No:	SB159-16	Issue:	1
Date:	09/05/2016	Sheet:	Page 1 of 1

**SUBJECT:** Hendrickson Rear Air Suspension Shock Absorber Bolt Torques

### Shock Absorber mountings

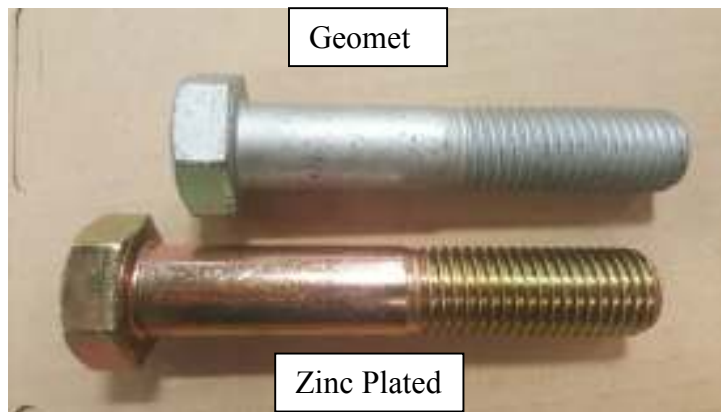
During the vehicles next scheduled maintenance check, it is recommended that the shock absorber top and bottom mounting bolts are identified, torqued and maintained to the following values.

Geomet (Dacromet or Deltaprotekt differing trade names. light grey appearance) 330Nm.

Zinc plated (Clear, Olive or Yellow shiny finish) 425Nm.

**Please note:** Either bolt type could have been used in the mounting of the shock absorber so it is important that the correct identification is made.
